Planning Commission

Application for a Modification of a Conditional Use and Final Development Plan Approval regarding a Façade Change for Camargo Cadillac (**Tabled**)

9880 Montgomery Rd

March 4, 2024

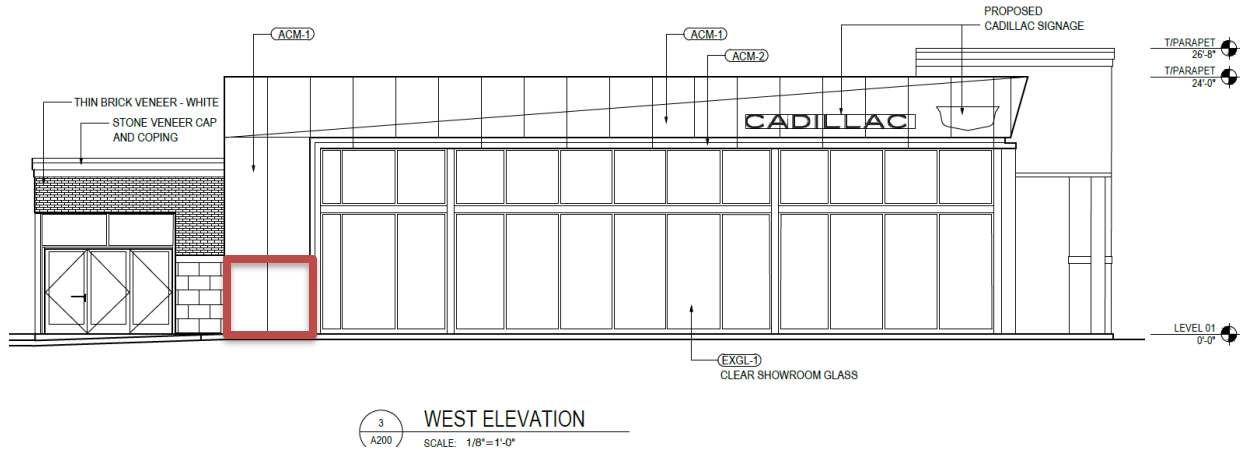
- While the sides of the proposed structure appear to meet the intent of the guidelines, the front façade with flat ACM panels does not provide variation or material changes.

1. Discussion regarding adding a stone base on the western side (and wrapped around to the north) of the structure fronting Montgomery Road indicated below in the **red area**.

SHEET #  
**A201**

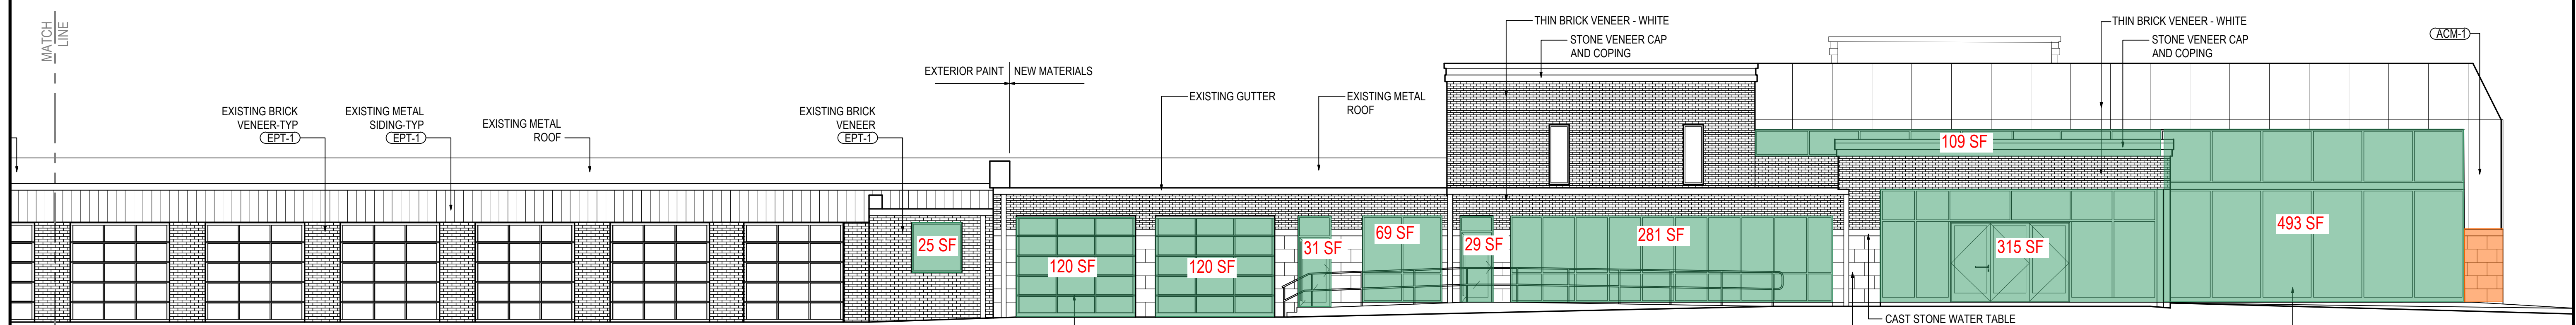
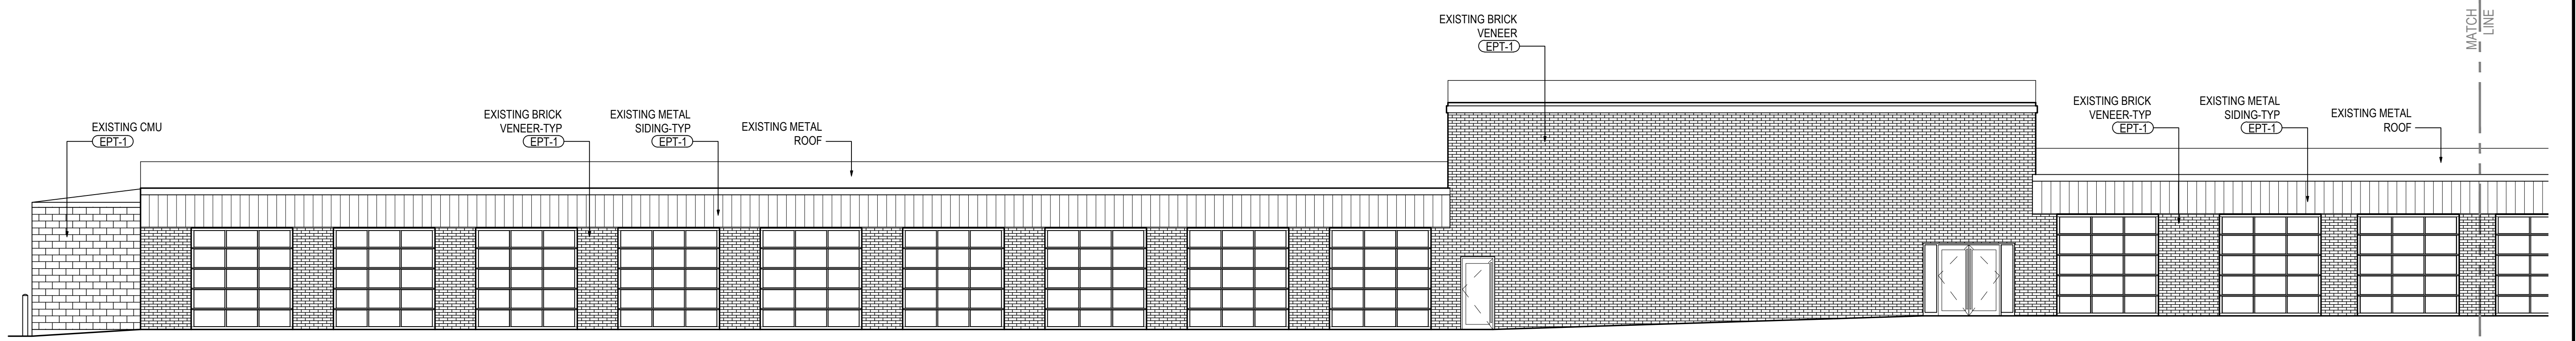
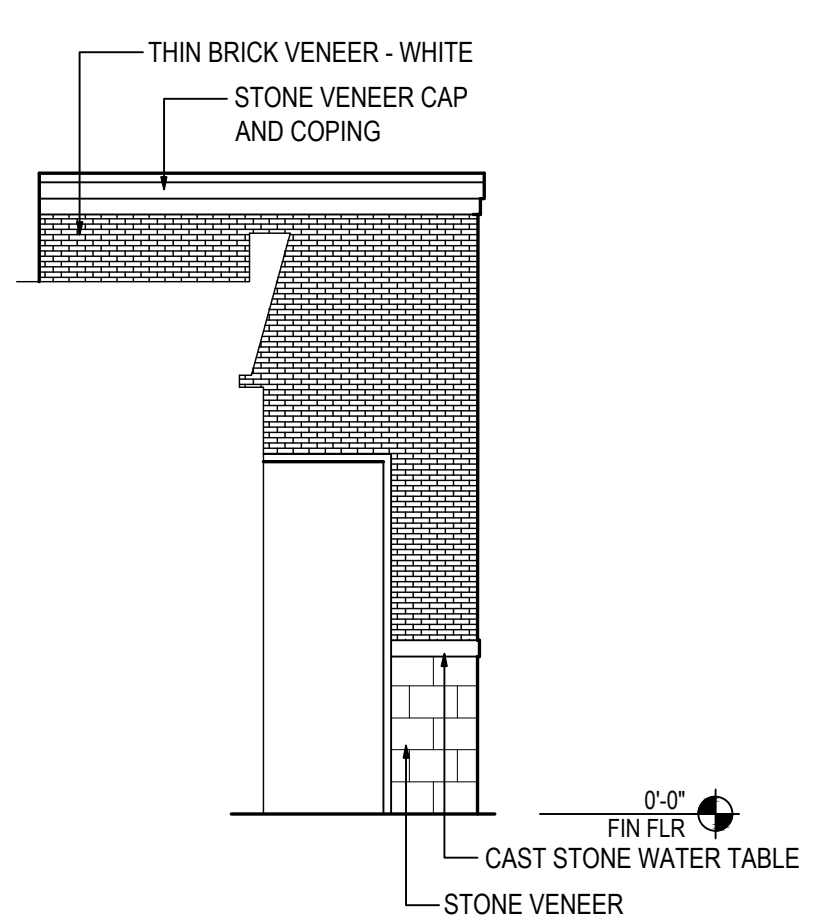
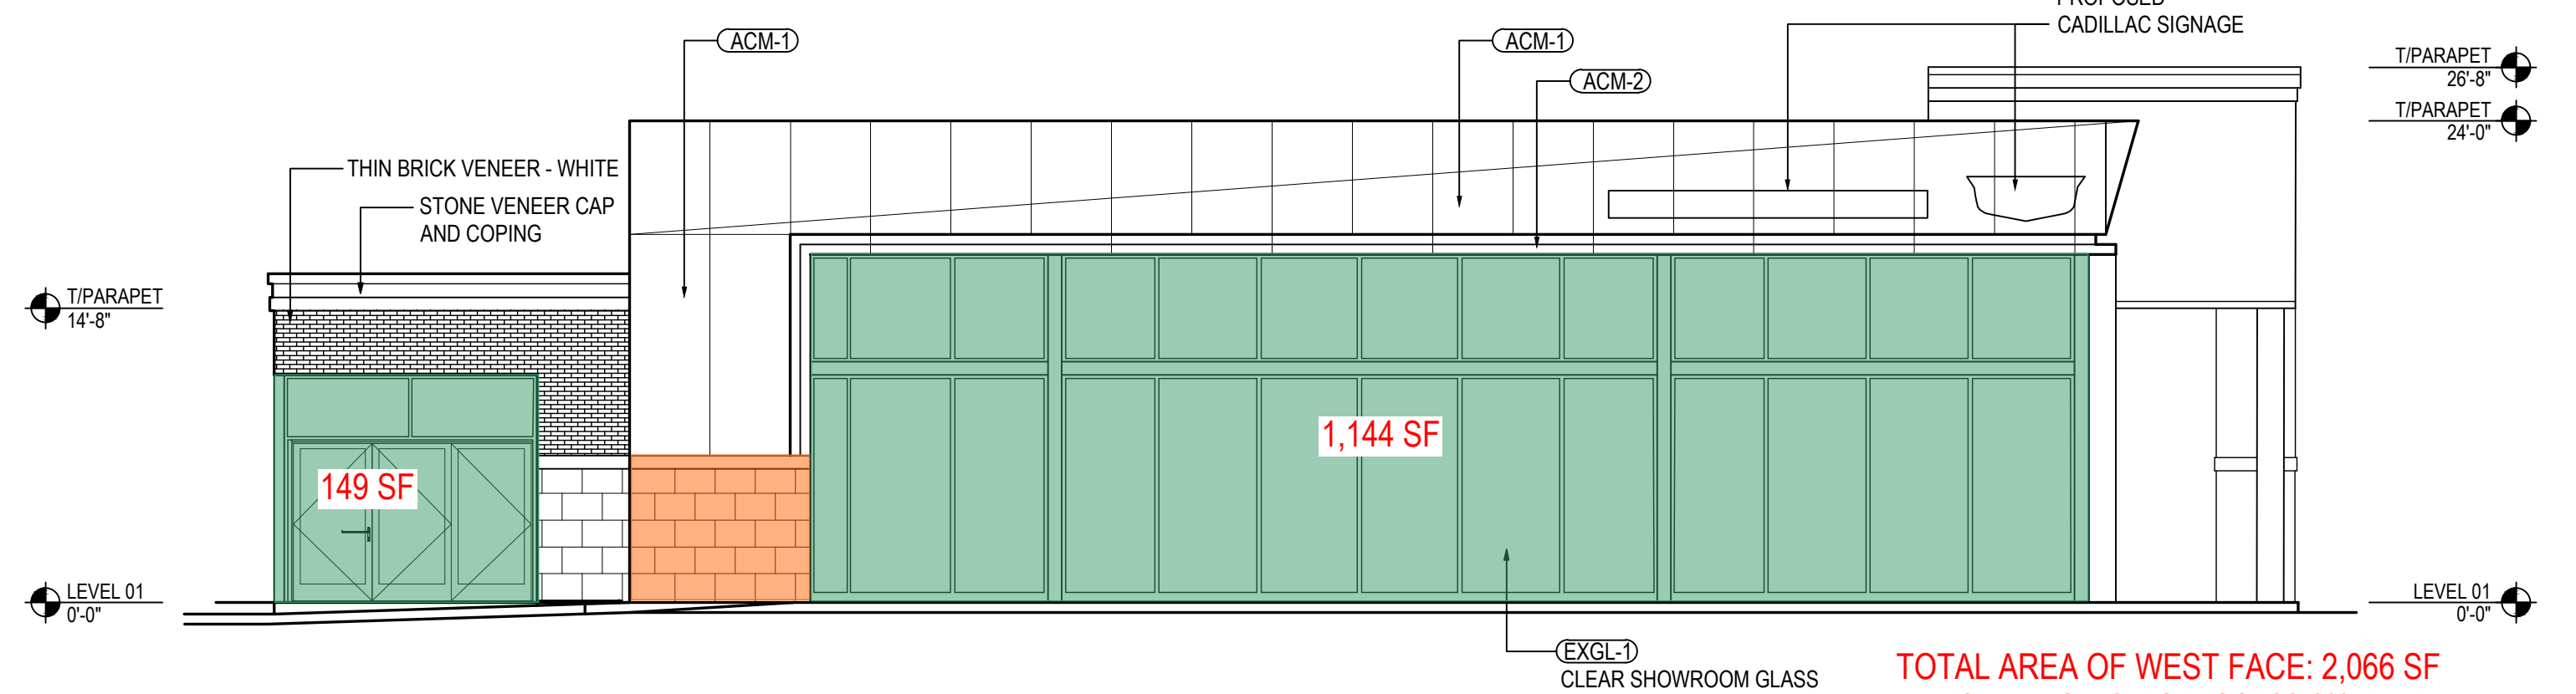
The applicant has provided an updated elevation drawing proposal for Planning Commission review and discussion. The new elevations show an additional stone base material added to the front façade as well as material percentage areas and calculations. The last Planning Commission discussion centered on the possibility of matching the stone/brick height of the front façade with the approximate height of the porte-cochère mix of brick and stone materials (generally in green below) as well as on the south side near the entrance. The application does not reflect that as an option but does show a stone based added at a lower scale without the additional brick.

As required by the building materials standards, the applicant has also listed the percentage of primary materials, glass and ACM. Specifically on the front façade, ACM is 28.2% of the area. It should be noted as was previously discussed that ACM is not listed as an accent material but, the Commission has permitted metal paneling on previous buildings (i.e. Fifth Third & First Financial) on a limited basis.

Midday Friday, the applicant has also provided information regarding the percentages of materials for the remainder of the building but, staff would request clarification if the area is inclusive of the entire side or only to essentially the auto repair bays. Further conversation regarding the use on ACM on the northern roof area versus other materials such as brick may be warranted in light of the design guidelines.
